# Certificate of Appropriateness

**Property** 3252 N. LAKE DR. North Lake Drive Estates Historic District CCF #170367  
**Description of work** Relocate door and canopy to nearer west corner, per drawings. Retain westernmost two windows. Eliminate easternmost window, matching basement window and infill window well. Install new all wood window to match existing trim and muntin profiles in all wood to match drawing immediately east of new door location. Second easternmost window may be relocated up to one foot from its present location. Shutters to be reused/built as shown. Retain and reuse all lintels. Retain and reuse storm windows, any new storm window for new window must match existing and be all wood.  
**Date issued** 8/22/2017 PTS ID 114302 COA: North wall alterations

“Before” elevation, not showing present porte cochere

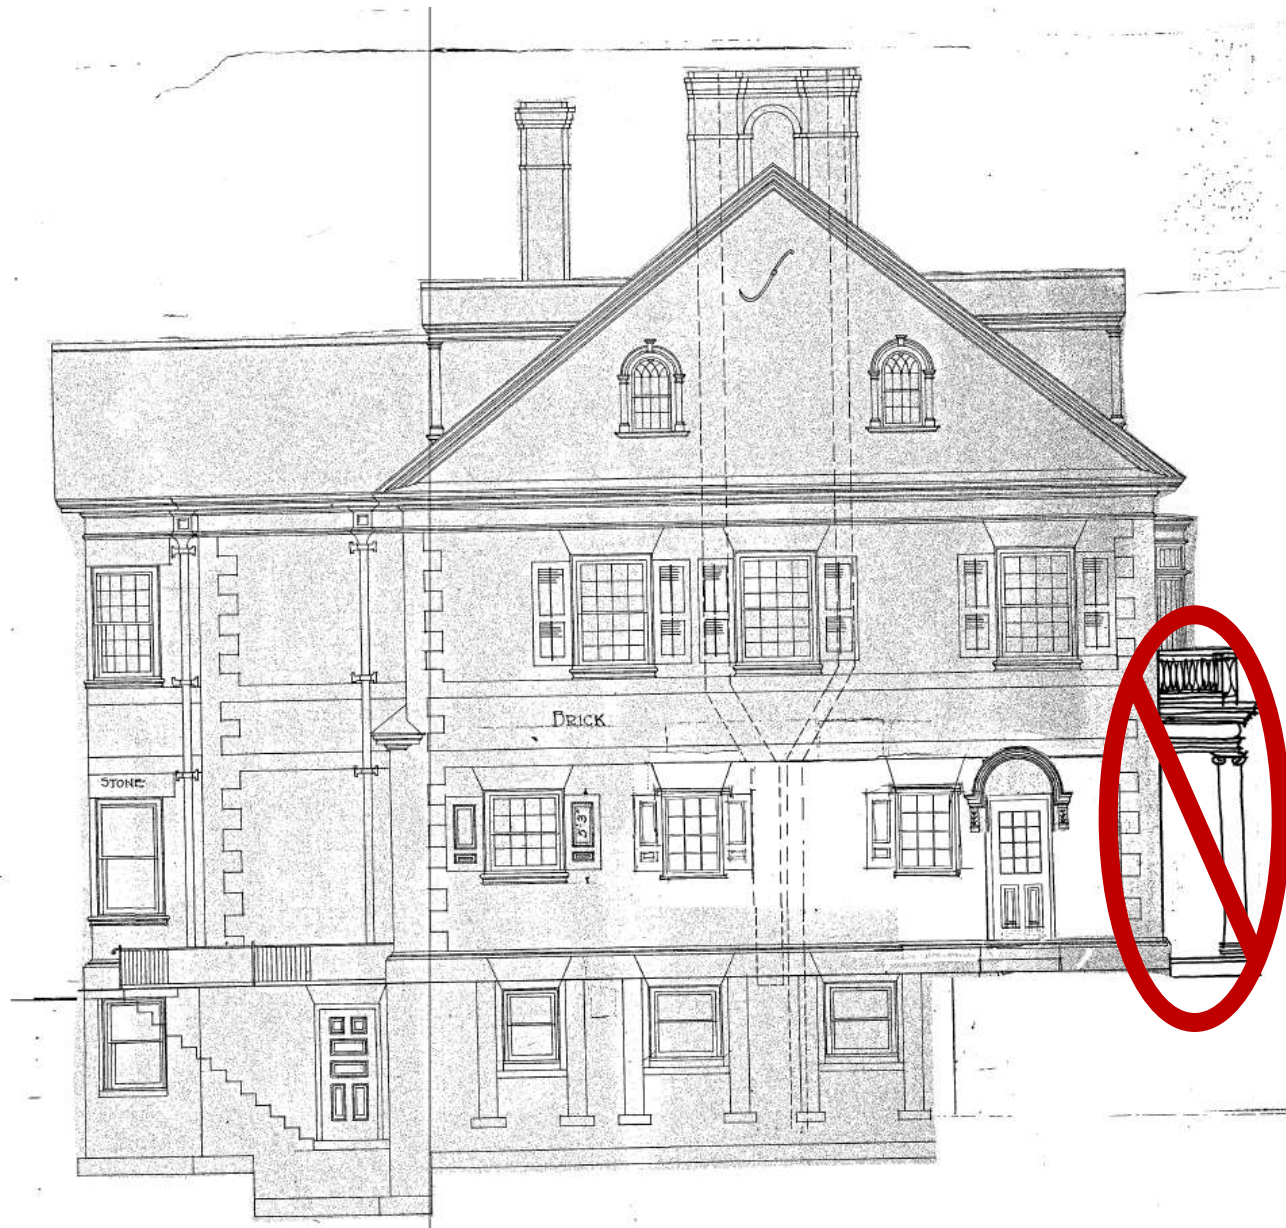
Final proposal, existing porte cochere is to remain, although not shown. Front entry alterations are excluded from this project and are not approved (see “no symbol” above).

Door details. Barbeque will be removed. Door and canopy to be installed at new location.

Angled view of north elevation. Barbeque will be removed and PVC pipes must be painted to match surrounding brick. Shown windows will remain in place.

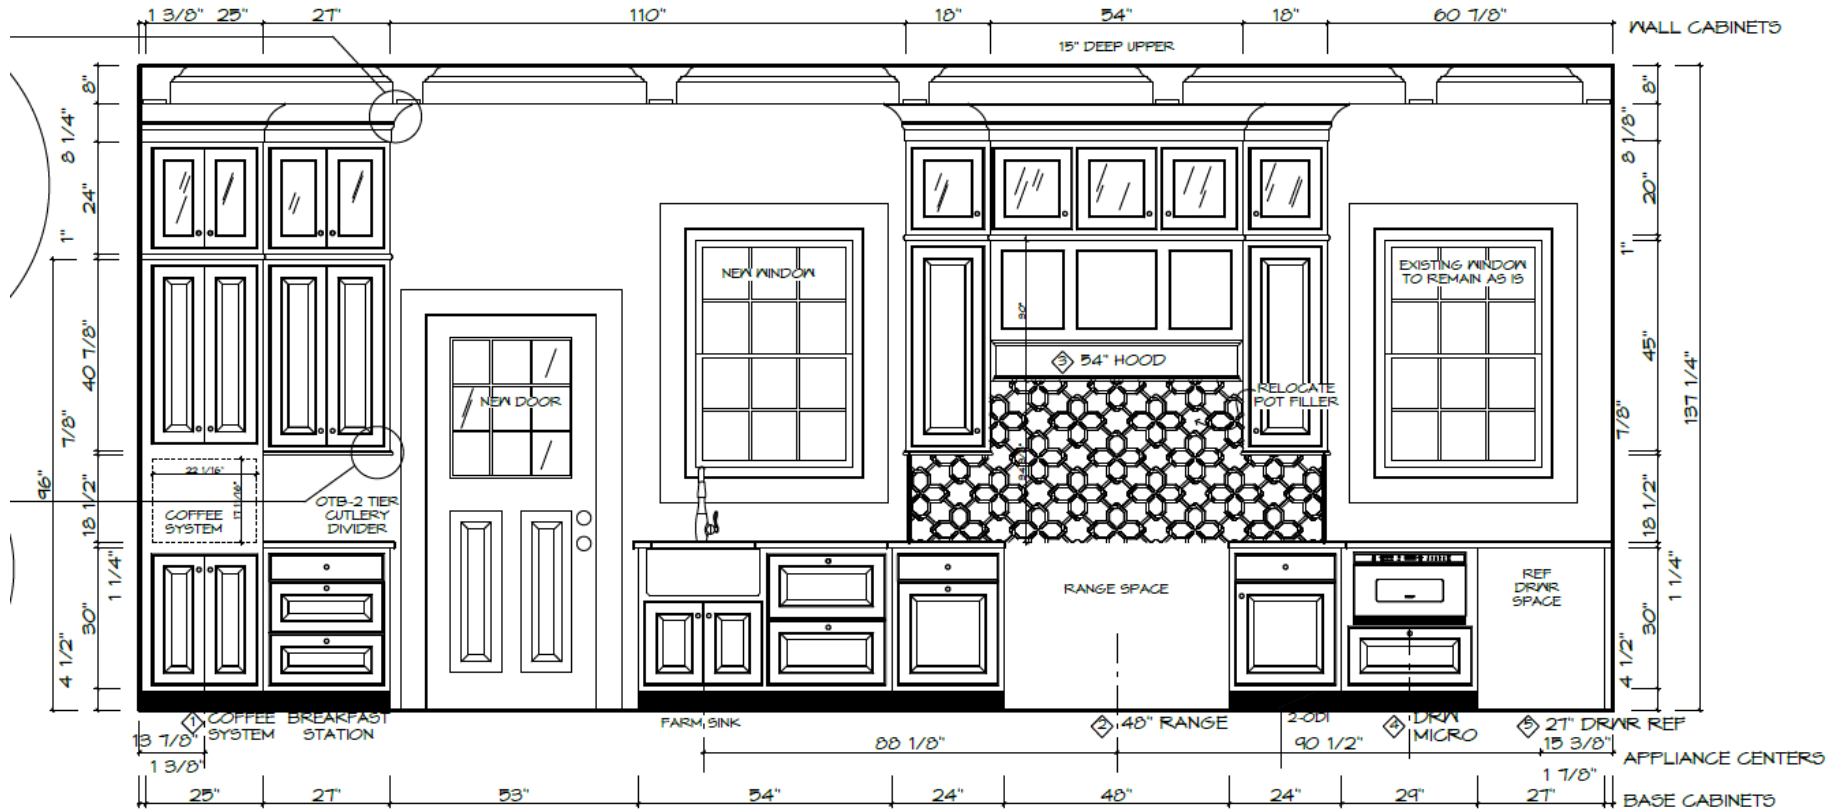
Window and well to be eliminated.

**A RANGE WALL ELEVATION**  
 SCALE: 1/2" = 1'-0"

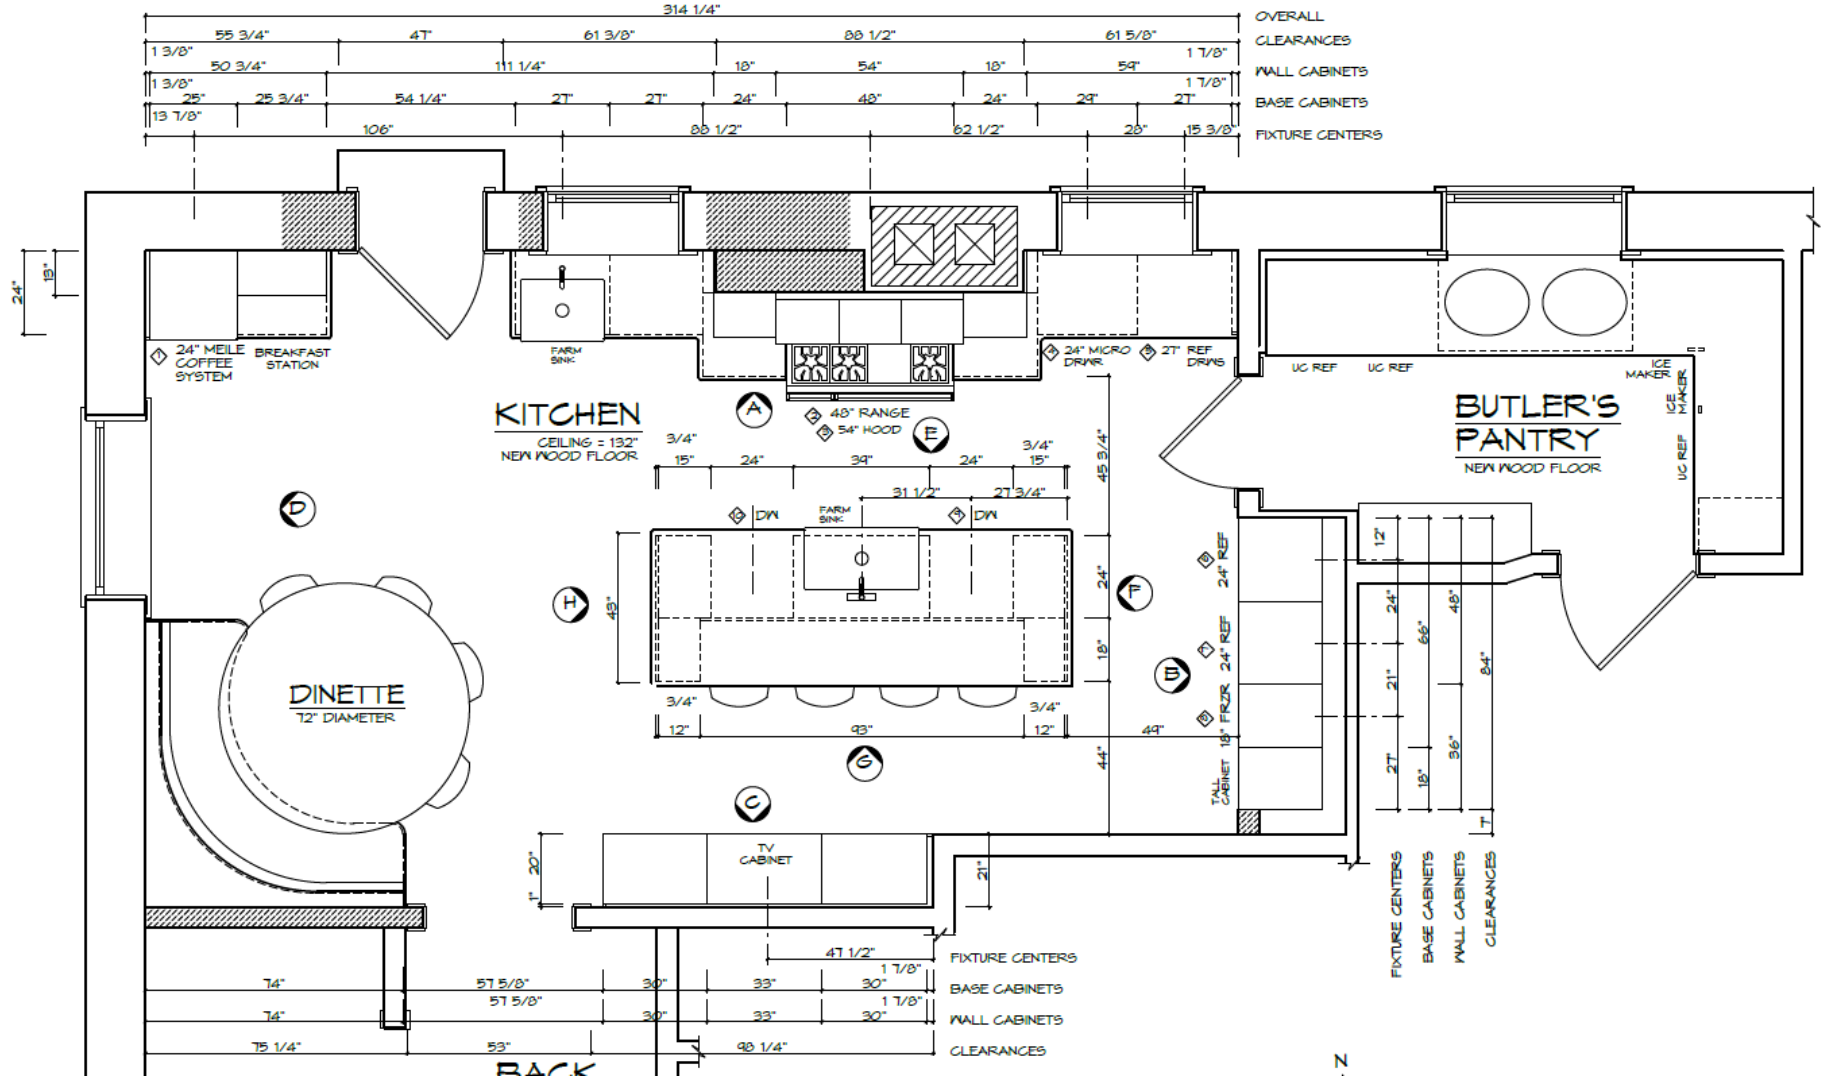
Interior elevation of north wall. Existing door must be reused. New door as shown is not approved.

Portion of plan showing effects on north wall. Existing door must be reused.
